PLANNING COMMISSION

February 28, 2024 – 7:00 PM

From: Ken Roberts, City Planner

Re: Site Plan Review – Proposed Dental Clinic

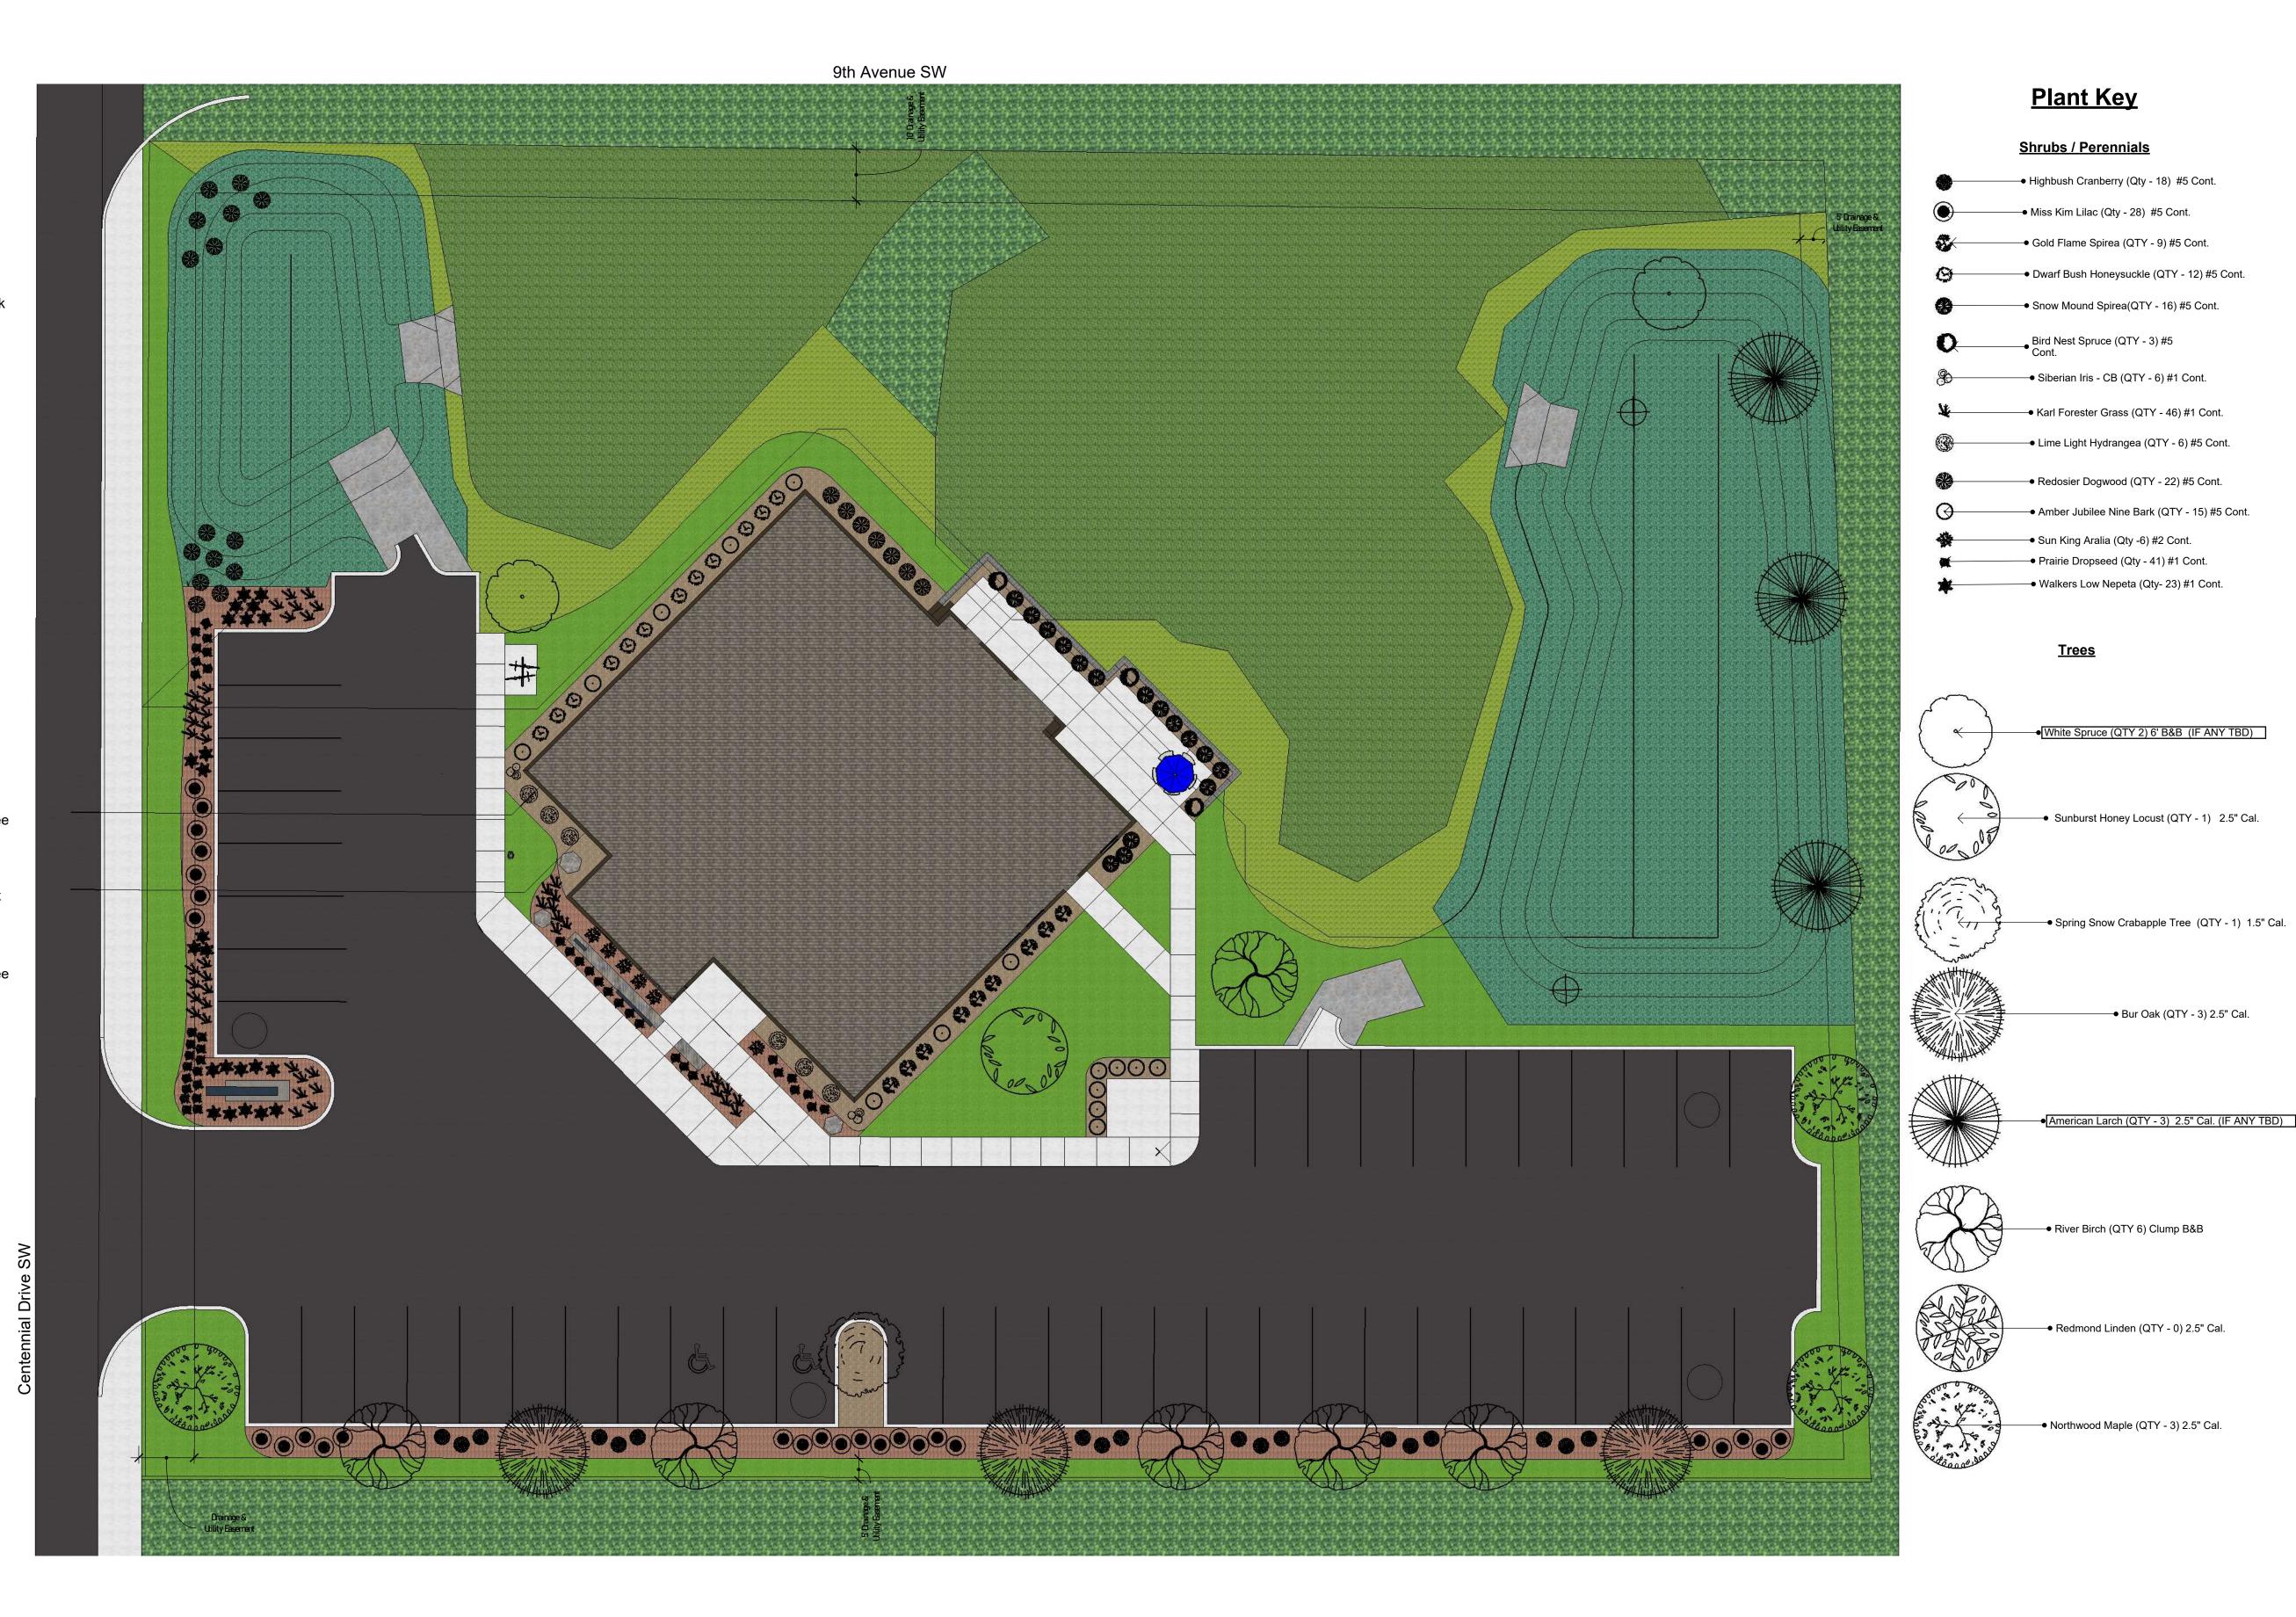
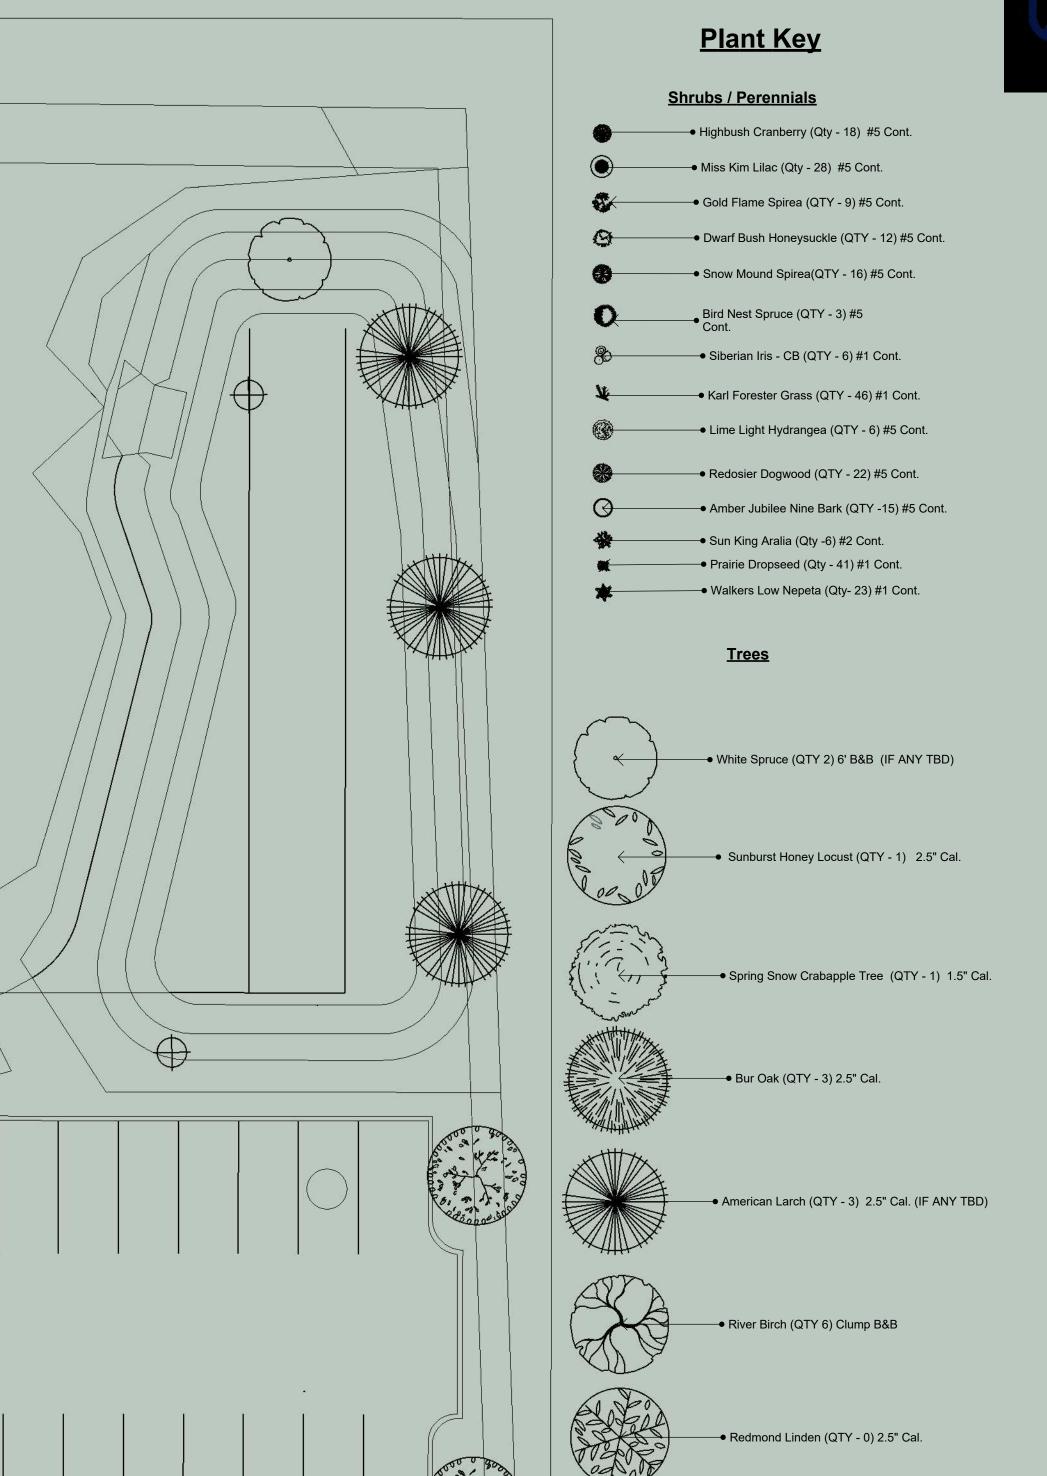
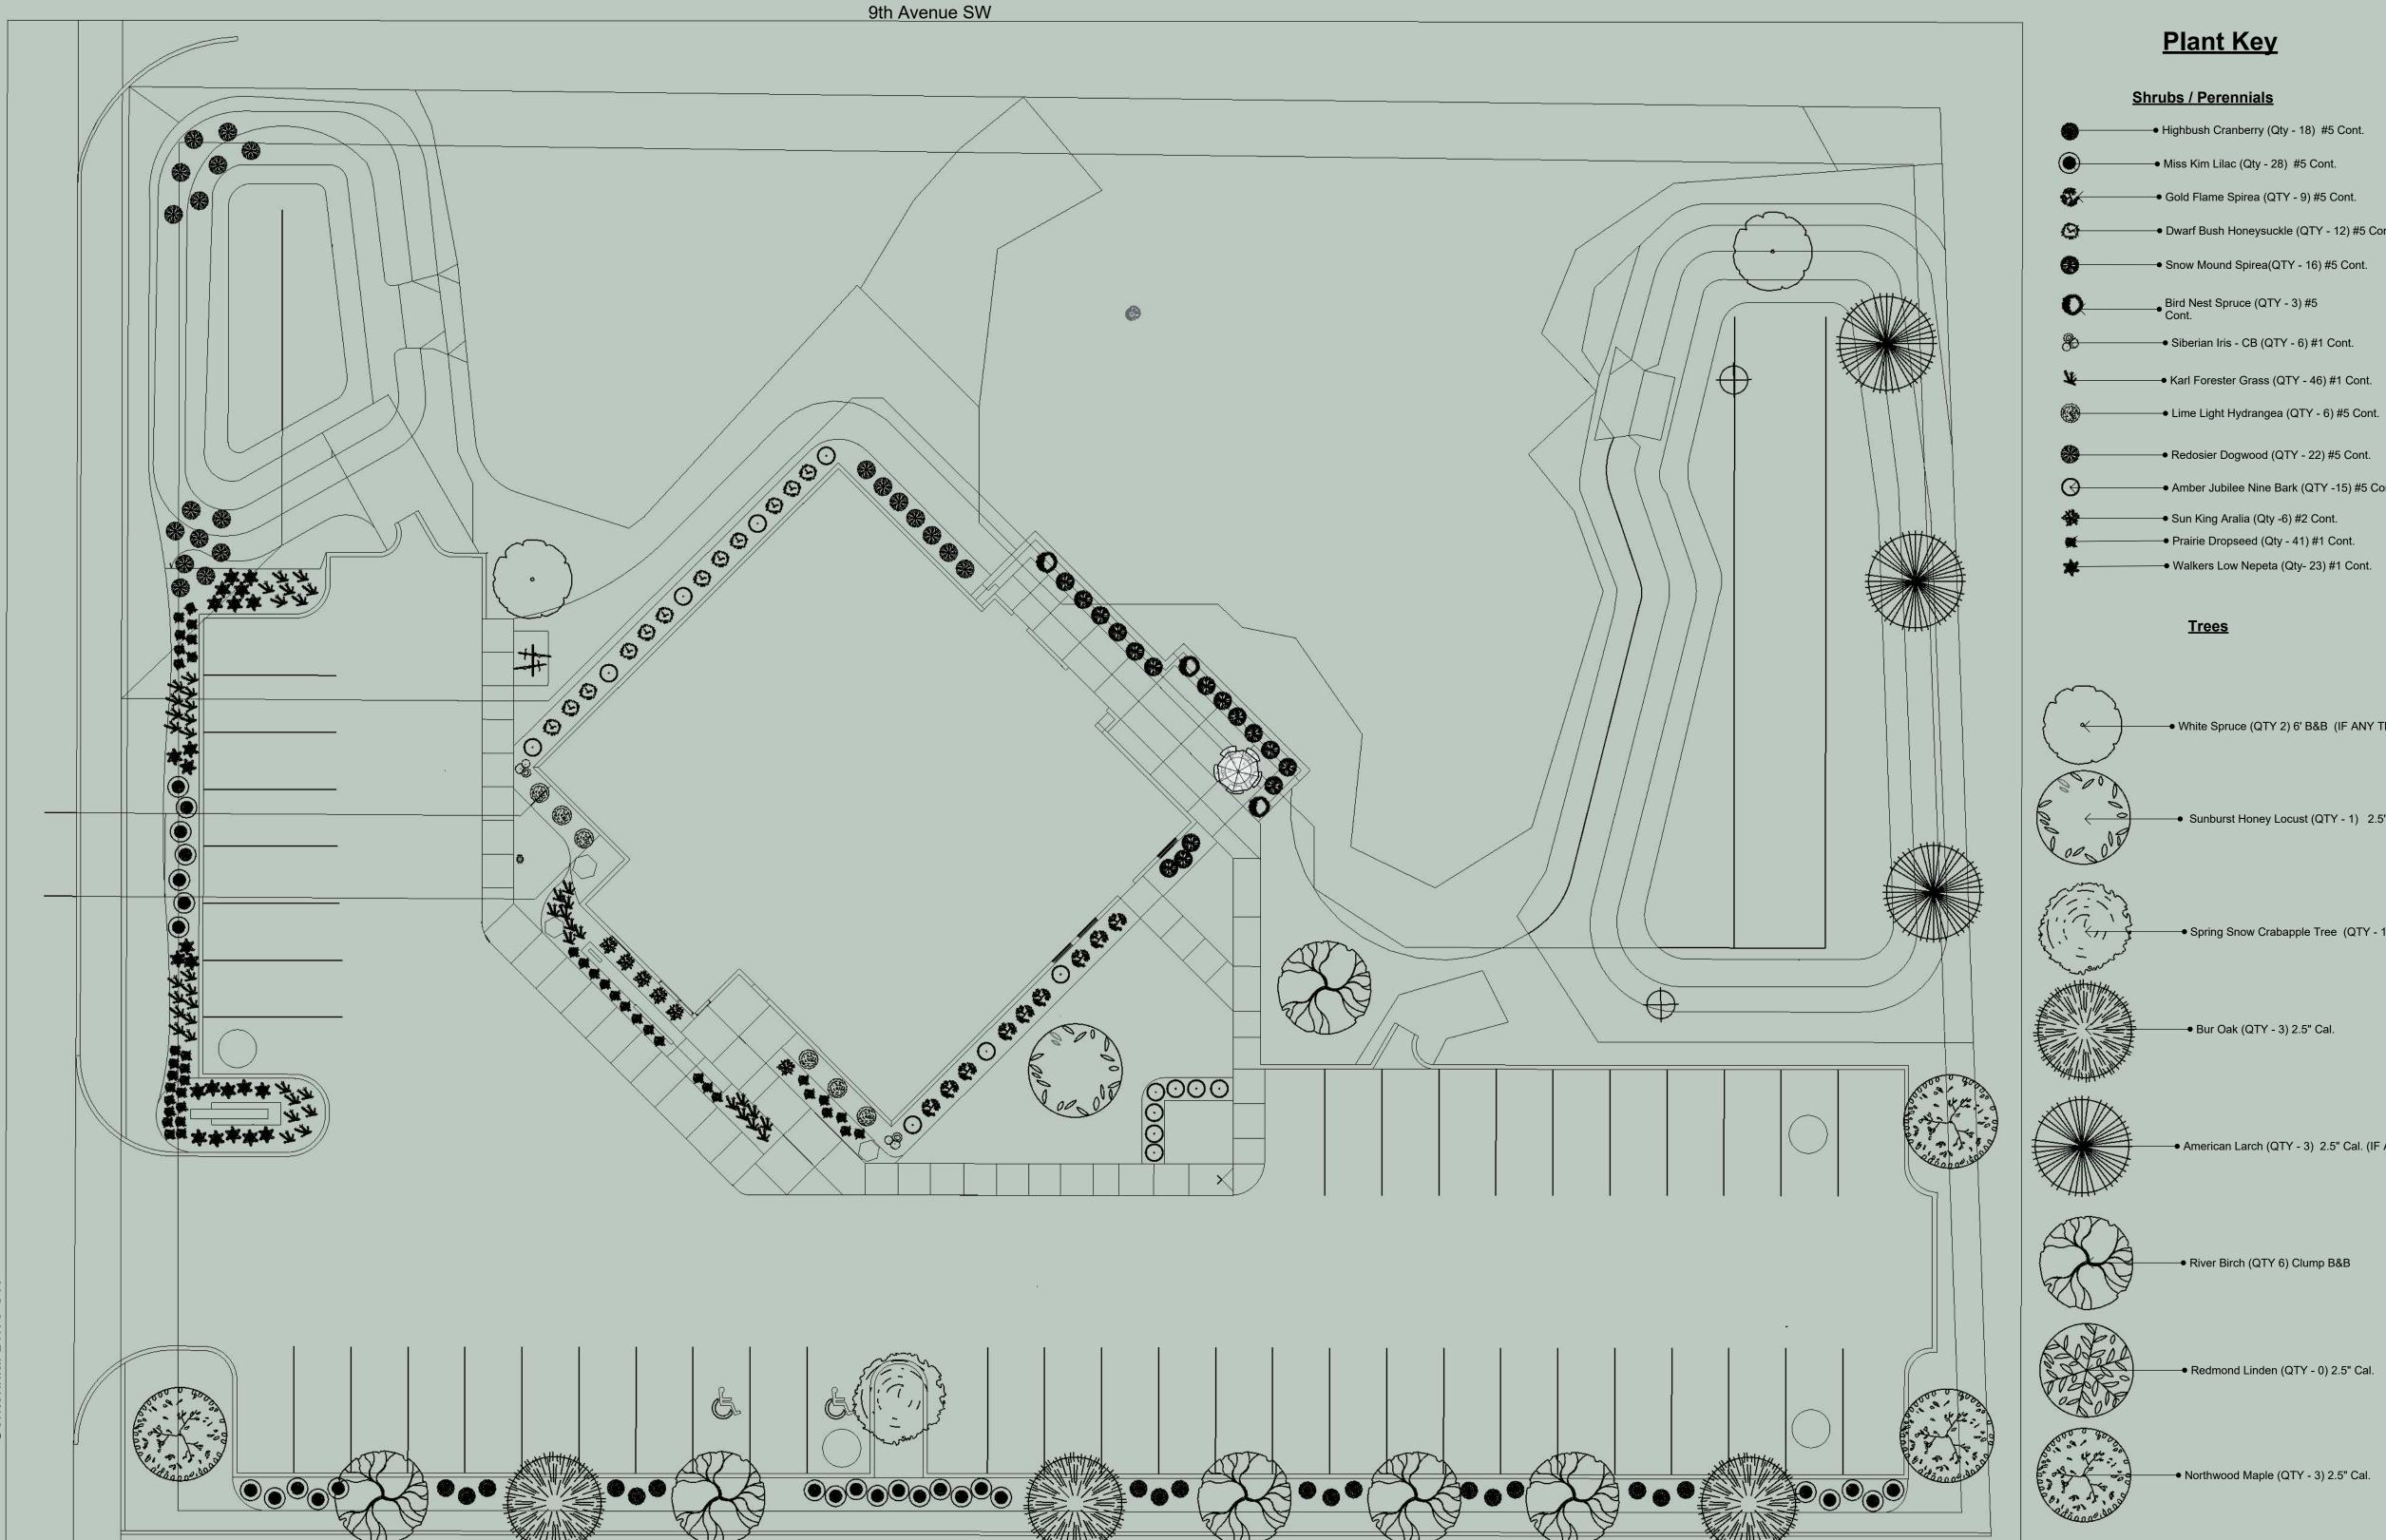
The proposed landscaping plan for the site (dated February 8, 2024) details three varieties of trees for the seven proposed trees considered to be overstory trees. The seven proposed overstory trees do not meet the City requirement of planting at least 33 trees for this site. The proposed landscaping plan also shows the potential for planting of another five trees depending on the final grades and soil conditions in those locations.

As noted in the table above, the proposed landscape plan for the project site includes 136 understory trees and shrubs, 36 more than the 100 plants required by the City Code. The landscape plans also show the planting of a variety of shrubs and perennials in the area between the parking lot and the sidewalk along Centennial Drive to meet the City screening requirements for parking areas.

City staff are aware it may be challenging for the applicant to plant 33 overstory trees on the property while meeting all City requirements and while keeping the new trees out of the existing wetland and the proposed storm water ponds. The goal of the City is to have a development with professional landscape design and installation with trees and plantings of a high-quality and quantity of plant materials. In all cases, City staff expect the landscaping of a new development to complement the project site, the existing natural features and existing development on adjacent parcels. In summary, the proposed and expected landscaping, with the changes recommended by City staff, should substantially conform with City landscaping standards and they will meet the intent of the landscaping design requirements found in

Landscape Irrigation – Section 153.235 (D) (5) of the Code requires the installation of an irrigation system for landscape areas as may be determined by a landscape architect. The proposed project plans do not show irrigation for any of the proposed landscape areas. The applicant should revise the project plans to show irrigation in the landscape areas that will need it to help ensure the plantings will survive and thrive. If the applicant wants to revise the landscape plans to show areas with plant materials that require little or no water as part of a sustainable design and thus will not need irrigation, they can submit the revised landscape plans to the City for approval.

- e. Irrigation in the landscape areas that will need irrigation to help ensure the plantings will survive and thrive.
 - f. The use of native plantings in the new landscape areas that are tolerant to harsh conditions.

- g. Additional tree and shrub planting wherever possible on the property that will not be in easements and will not interfere with the function or maintenance of the proposed storm water ponds.
